## NOTICE OF DECISION

**Case File:** T2-2014-3349  
**Permit:** Design Review  
**Location:** The southeast corner of the intersection of SE Dodge Park Blvd and SE 302<sup>nd</sup> Ave.  
Tax Lot 400, Sec 20, T 1S, R 4E, W.M.  
Tax Account # 994201070  
**Applicants:** Michael McKeel  
Multnomah County Rural Fire District #10  
**Owners:** Susan Lorain Trust  
**Base Zone:** Multiple Use Agriculture-20 (MUA-20)  
**Overlays:** None

**Summary:** Design Review for a new fire station, two parking areas, landscaping, and a training pad.

**Decision:** Approved with Conditions

1 FIRE STATION 76 - SITE PLAN  
1" = 60'-0"

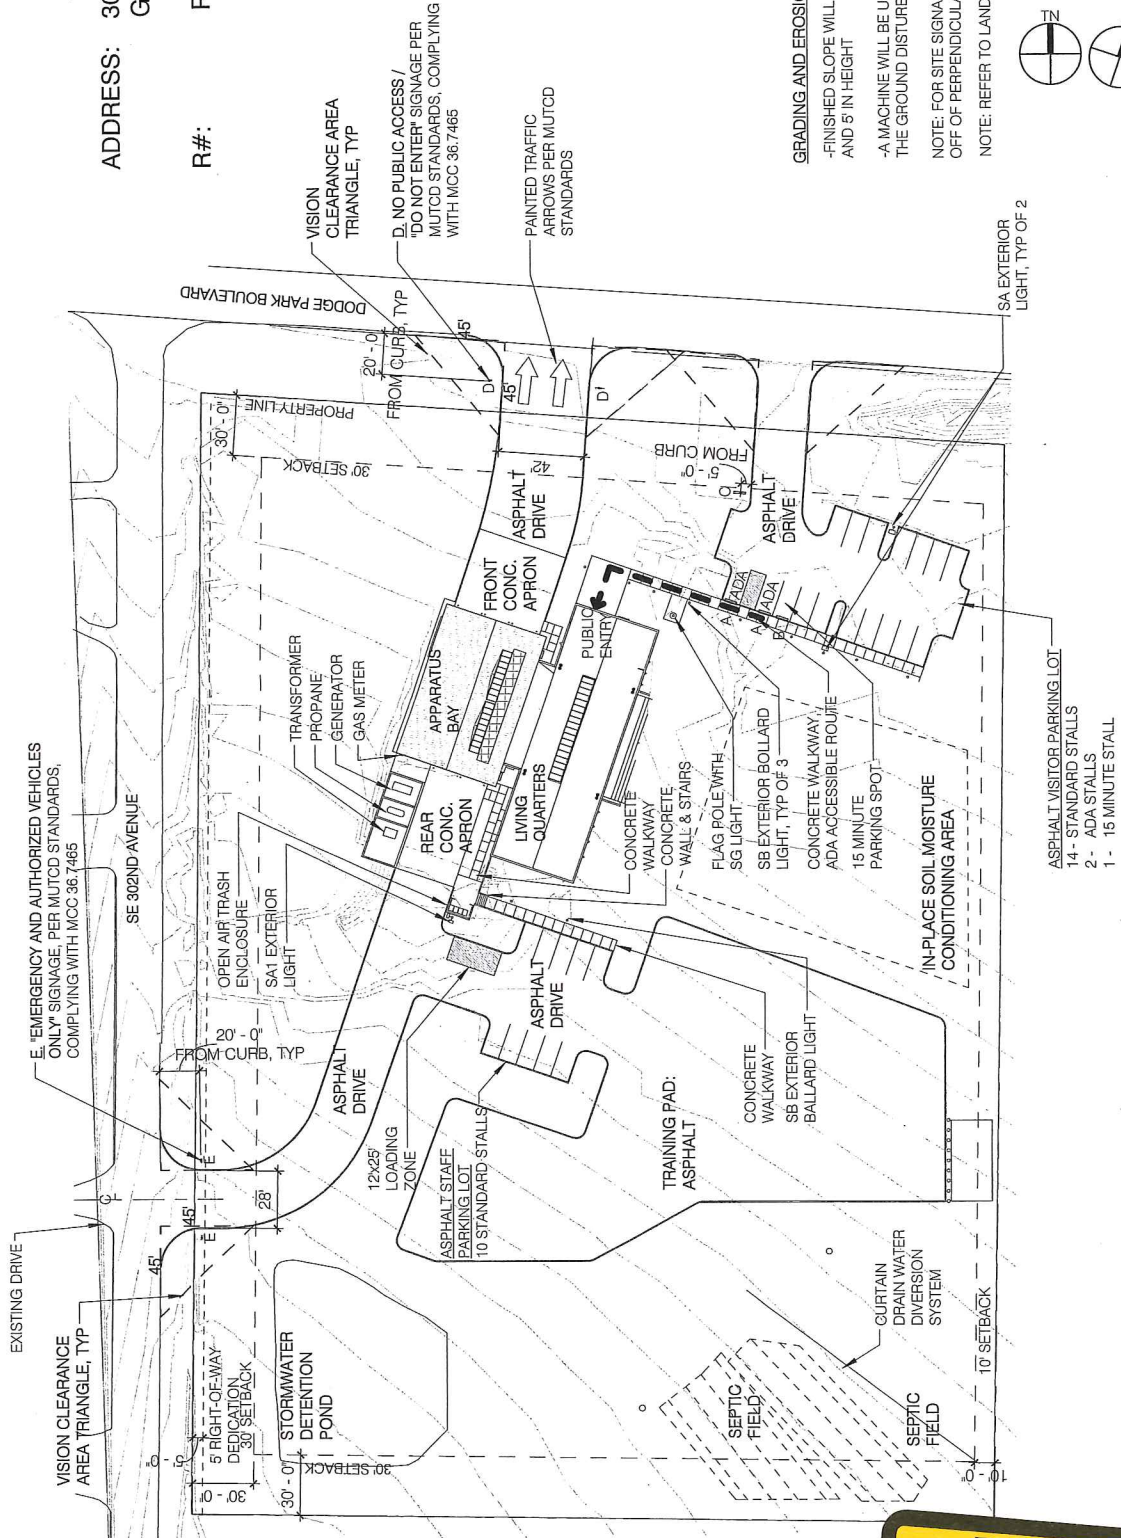
**Staff:** Storm water drainage was reviewed as part of T3-2014-3149. A condition of approval from that land use decision requires the drainage pond shown on the site plans (Exhibits A.23) to adequately handle the storm water runoff resulting from the new impervious surfaces of the fire station, parking and training pad.

A.24

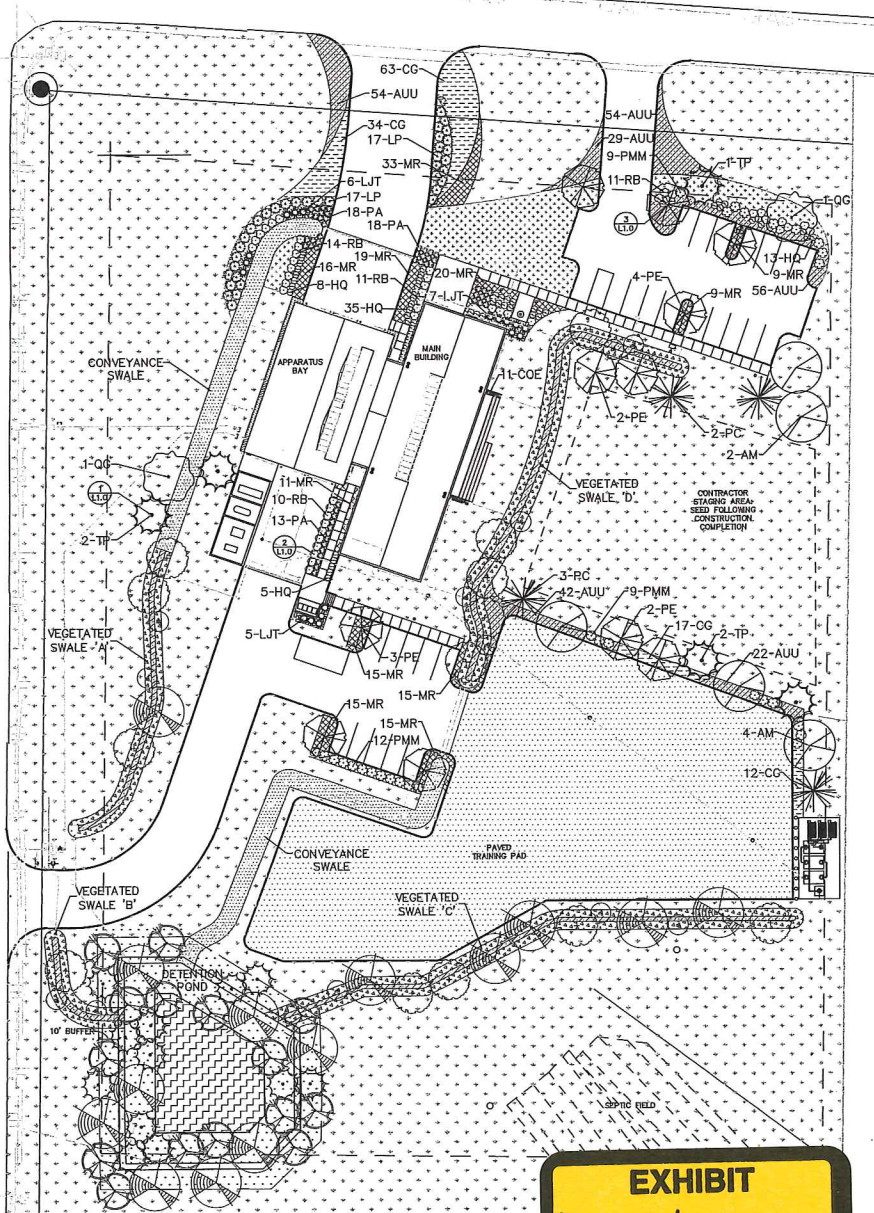
The applicant's last submission on August 5, 2014 noted they provided 170,189 square feet of landscaped area (Exhibit A.24, A.26). However, the applicant has interpreted grass lawns as being considered landscaping and proposed several large areas to be covered in perennial Rye grass – a common lawn grass.

As discussed with the applicants, Multnomah County does not consider lawns to be landscaping under the Design Review landscaping code. Design Review's purpose is to review the "...design of certain developments and improvements in order to promote functional, safe, innovative and attractive site development compatible with the natural and man-made environment." The County's Design Review, like other jurisdictions, requires landscaping that features plants, bushes, trees and other decorative features as part of the landscaping design for visual interest and attractiveness. For businesses, schools, and other community service and conditional uses, lawn grass may be intermingled with other shrubs and trees to create distinct and purposefully designed landscaped areas with visual interest - such as picnic areas, park bench areas, pedestrian paths with mixtures of trees, bushes, shrubs, and grasses. However, expansive and open lawns do not qualify as landscaping for the purposes of design review for community services such as the Fire Station.

Based on the above interpretation, staff analyzed the landscaping plan and calculated the landscaped area as totaling of 29,615 square feet but rounded up to 30,000 square feet (Exhibit B.5 includes calculations). This number differs from the applicant's calculation of 170,189 square feet due to lawn and rough seed not being considered landscaping, staff not including identified landscaped areas in the Right-of-Way or including drainage swales that included only typical lawn grass. Based on this, roughly 2,700 square feet of additional landscaping must be provided.

The applicant's August 5, 2014 landscaping plan does not show landscaping in two areas where the codes requires it: Adjacent to the SE 302<sup>nd</sup> Access point and a 40-foot segment between the training pad and adjacent property to the east. A condition of approval will require a landscaped strip measuring 20-feet wide by 30-feet deep (the full 30-foot setback from the property line) on the north side of the access point to SE 302nd Ave. That will add approximately 600 square feet to the landscaping.

improved with a structure, parking, driveway, training pad or utility must be landscaped. As discussed in Finding 3.13, lawn grass is not considered landscaping for the purposes of Design Review of Community Service Uses. The applicant's Landscaped Areas plan (Exhibit A.24, A.25) calculates a total area of 170,189 square feet being landscaped, including 134,039 square feet of lawn grass. The lawn covers three main areas:

- The area of the septic system and back up septic field
- West of the apparatus bay (Approximately 20,400 square feet of open lawn)
- East of the living quarters (Approximately 13,000 square feet of open lawn)

The septic system and backup system areas cannot have landscaping trees, shrubs or bushes planted due to their impact on the functionality of the septic system and backup system area. However, the other two areas cannot consist of expansive areas of lawn grass and still satisfy this criterion.

- 2. The property owner shall plant a 20-foot wide landscape strip adjacent to the fire apparatus and staff ingress driveway the full length of the 30-foot setback on the north side of the SE 302<sup>nd</sup> Ave access point [MCC 36.7055(C)(1)].**

- 3. The property owner shall relocate the equipment located on the east side of the training pad to accommodate the required screening vegetation. In place of the equipment area, the property owner shall continue the 5-foot wide planting strip around the training pad along the 40-foot length where the equipment was located in order to comply with a vegetative screening condition adopted in case file T3-2013-3149 [T3-2013-3149; 36.4200(A); 36.7050(A)(7); MCC 36.7055(C)(1); 36.7055(C)(3)(b)].**

**A. For the open lawn area directly east of the fire station and living quarters, the property owner may choose one of the following:**

- 1. The property owner shall reconfigure the 20 trees shown on the August 5 landscaping plan between the training pad and guest parking lot and locate them such that they are placed throughout the lawn area and break up the approximately 13,000 square feet of open lawn. The landscaped buffer around the training pad must also remain landscaped pursuant to the conditions of approval of T3-2014-3149. Additional plantings may be included at the option of the property owner.**

- 2. The property owner may choose to keep the proposed planting plan for the area between the training pad and guest parking area in the August 5, 2014 landscape plan and add 10 trees spread throughout the lawn area with the purpose of breaking up the approximately 13,000 square feet of open lawn. Additional plantings may be included at the option of the property owner.**
